PROJECT/SITE OWNER:	PROJECT SUMMARY:
Bayside Development Partners II, LLC	New mixed occupancy 5 story building
PROJECT ADDRESS: 600 Block of West Glencoe Place

**Re:** **Building C – Architectural Review Committee Submittal**

# ONE NORTH - MULTIFAMILY BUILDING C

VILLAGE OF BAYSIDE ARC REVIEW

# SITE PLAN

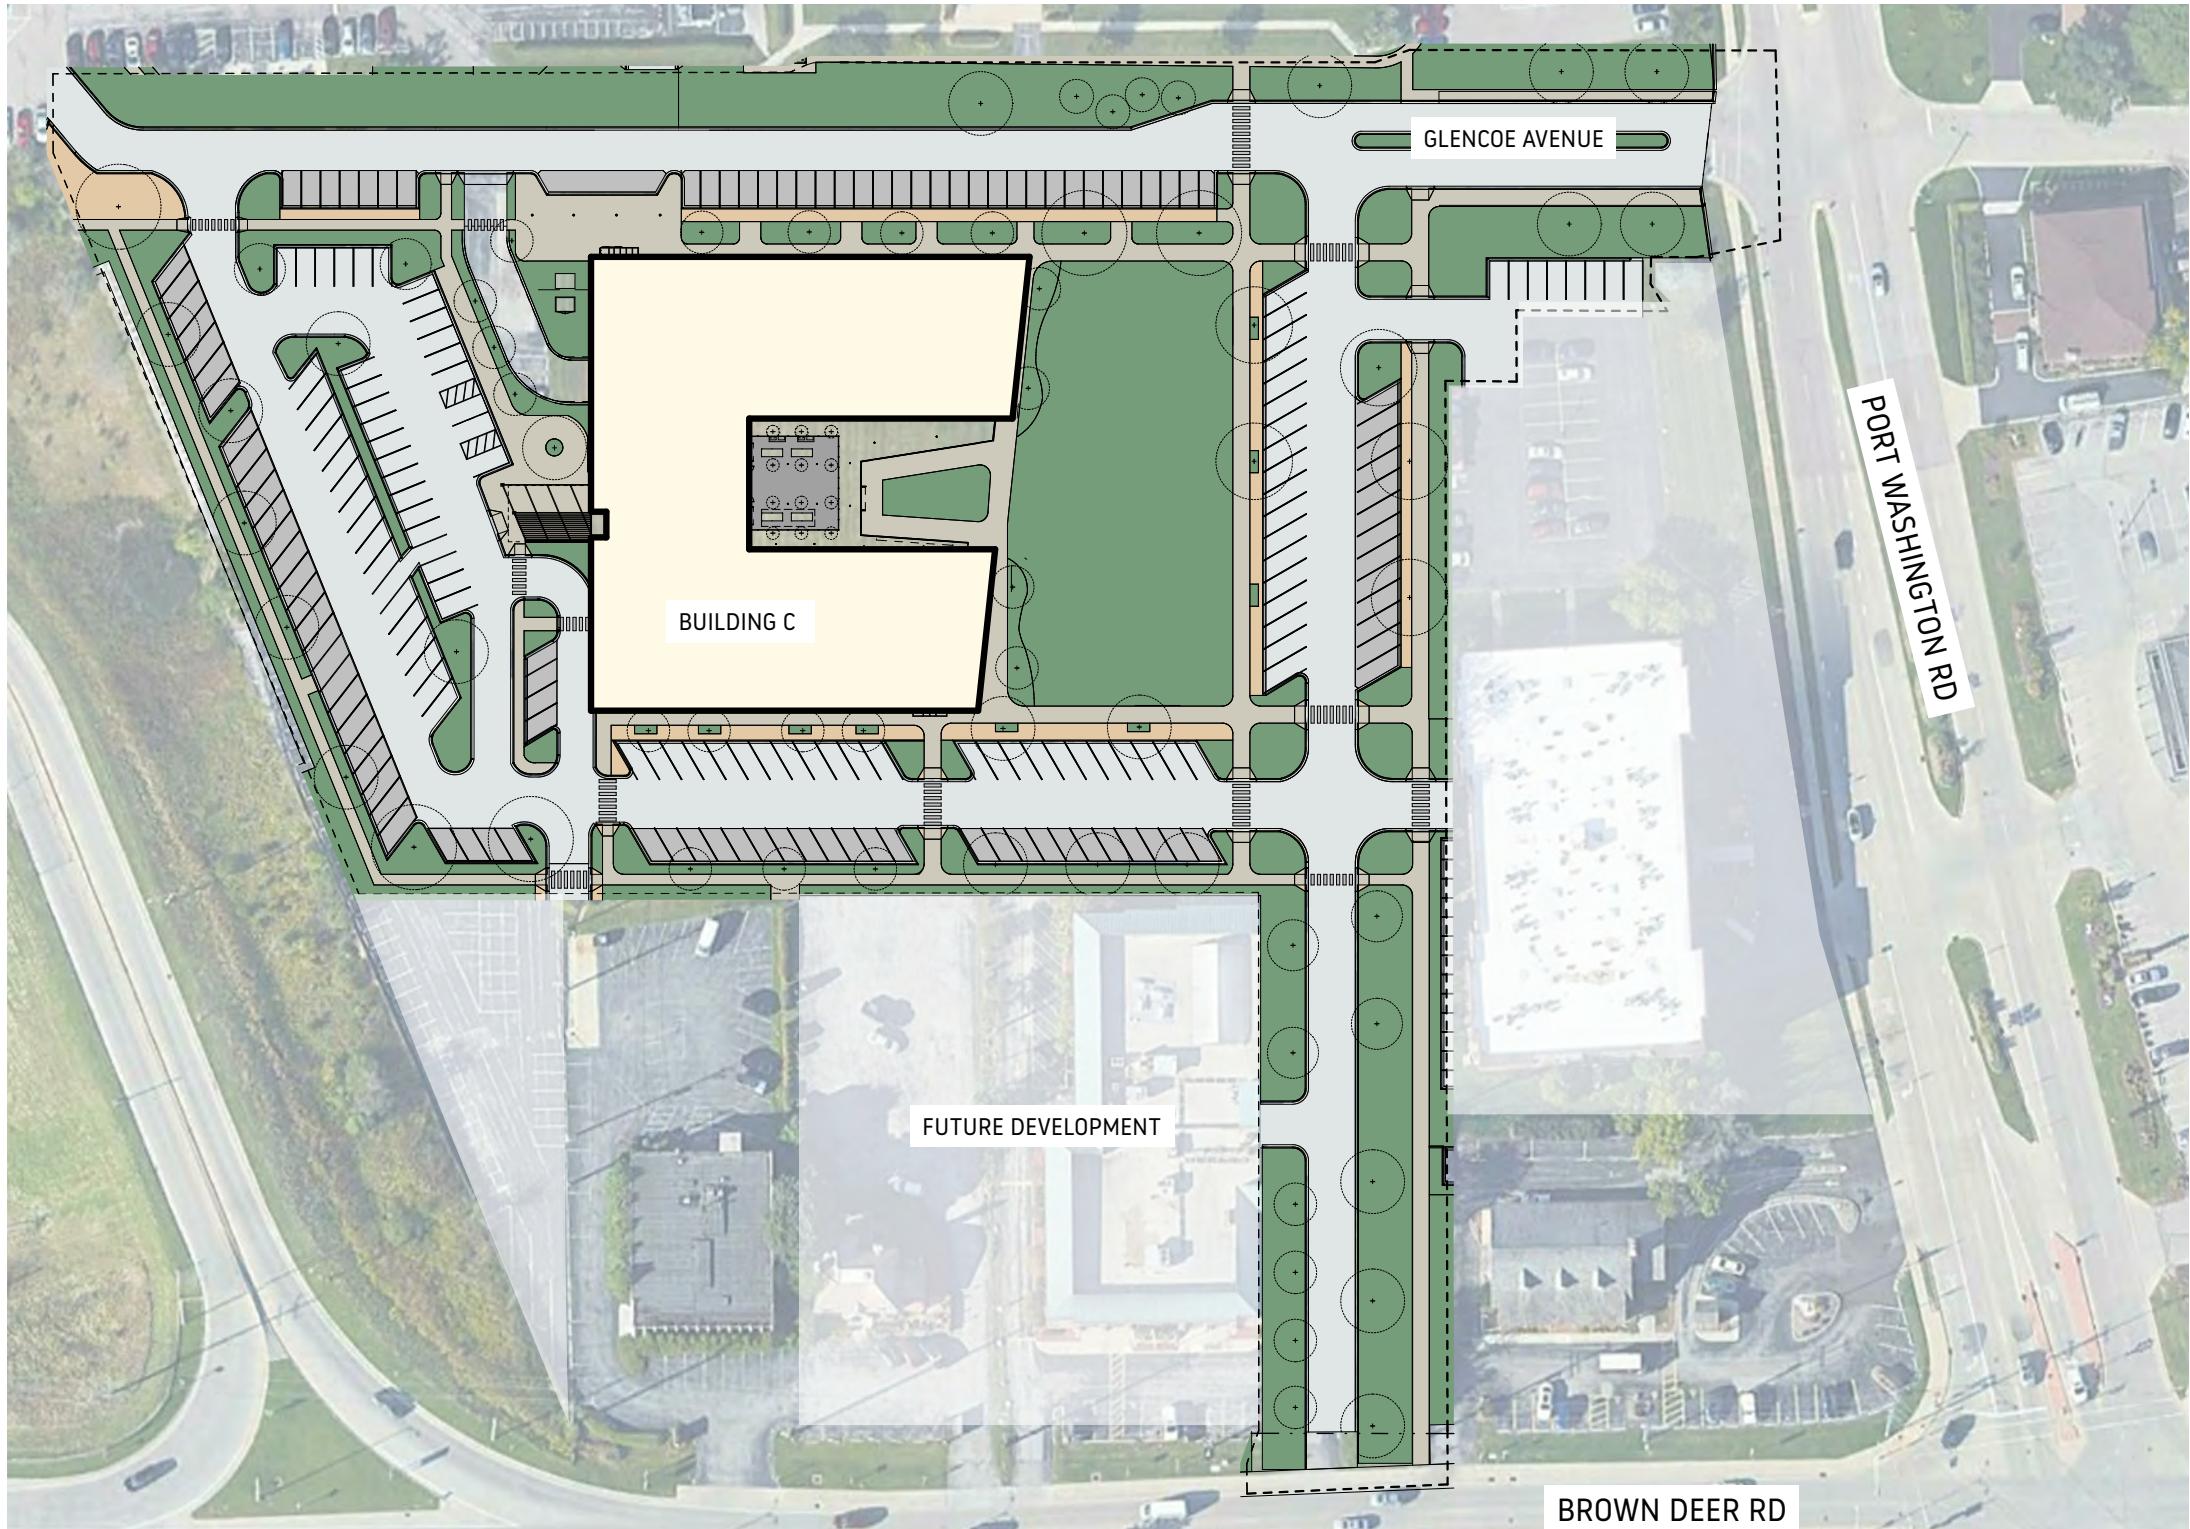
The Conceptual Site Plan for the larger development shows linked pedestrian greenspaces connecting the different phases of development, including a pedestrian connection to a planned greenspace to the northwest. These links are not clearly reflected in the submitted site plan. A key consideration for this site and other developments in PUDD 1 will be to ensure that these pedestrian connection, linkages, and thoughtfully planned greenspaces are integrated across the distinct developments as they are developed.

1. Add a pedestrian linkage to future greenspace associated with the future multi-family to the northwest of Building C.
2. Update the Conceptual Site Plan as buildings are approved to ensure that the Village has a comprehensive master plan reflects both planned and approved development. This will help ensure that PUDD 1 requirements are met sitewide, support careful planning of uses as plans evolve, and ensure that interconnectivity between buildings/sites is achieved.

# PARKING PLAN AND CALCULATIONS

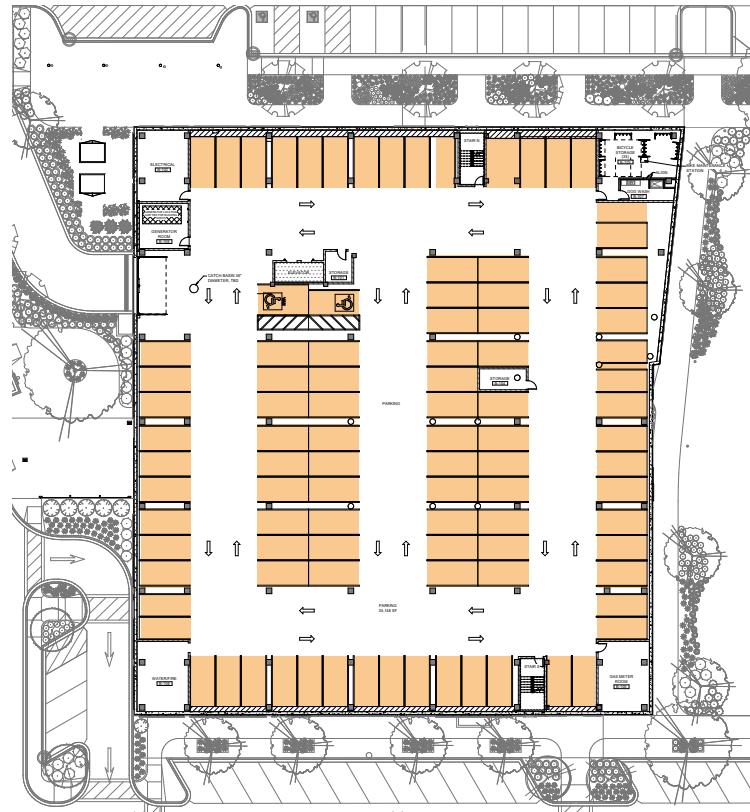
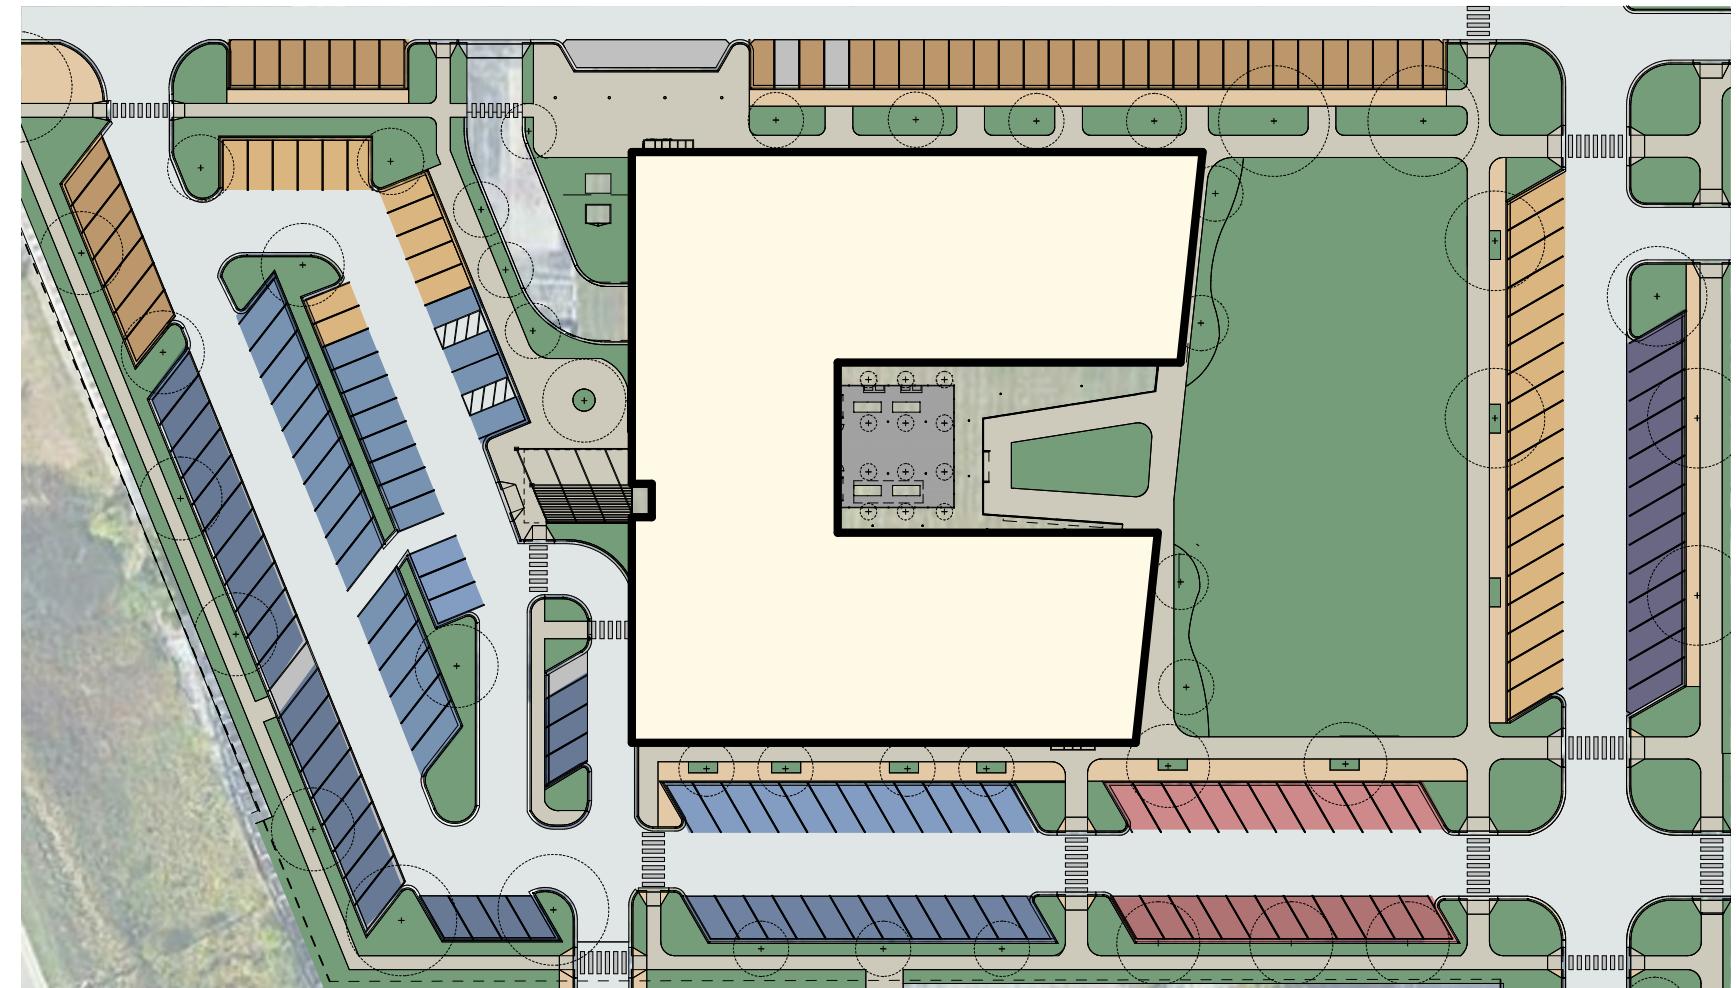
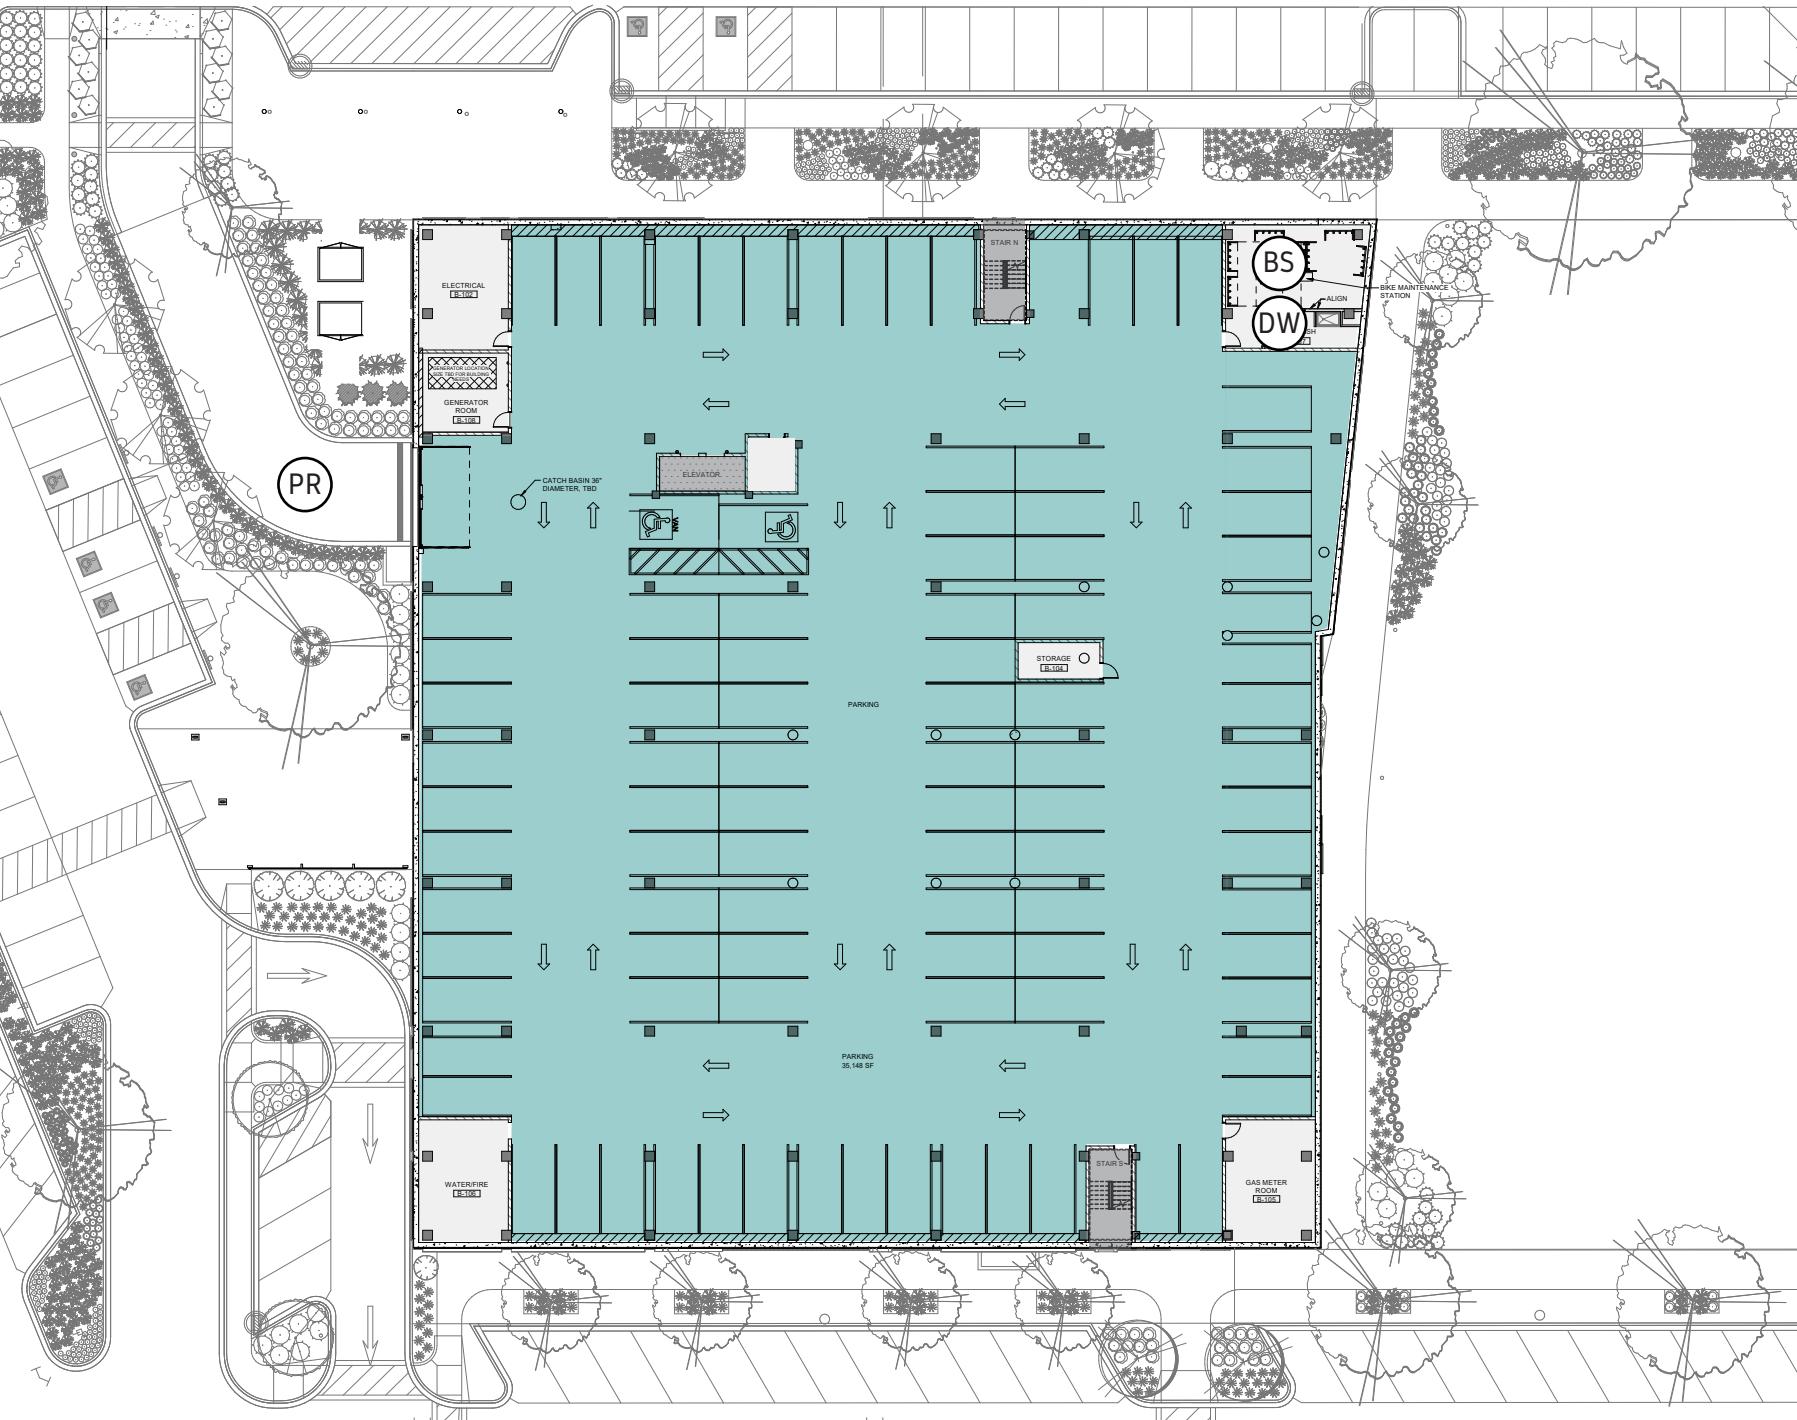
Proposed parking is depicted clearly on the “Parking Plan and Calculations” page of the submittal. Based on the size and number of the uses proposed, a total of 260 parking spaces are required. A total of 285 parking spaces are provided in the project, and therefore the project exceeds minimum parking requirements.

A minimum of 138 parking spaces are required to serve the 98 residential units. Parking requirements are met and exceeded through 98 underground parking spaces plus 71 surface parking spaces, for a total of 169 parking stalls for residents.

Based on square footage alone and assuming a total of 30,500 square feet of general commercial, a minimum of 122 parking spaces are required to serve the first floor uses. Only 116 parking spaces are provided for the first floor uses; however, given that the majority of the first floor will likely be devoted to library space, and given that total parking requirements are met and exceeded, the Plan Commission could consider a modification to the mix of parking permitted.

3. Approve 116 parking spaces for the first floor tenants rather than the 122 required, as the total minimum parking requirements for Building C as a whole are met and exceeded. (Requires approval by Plan Commission)
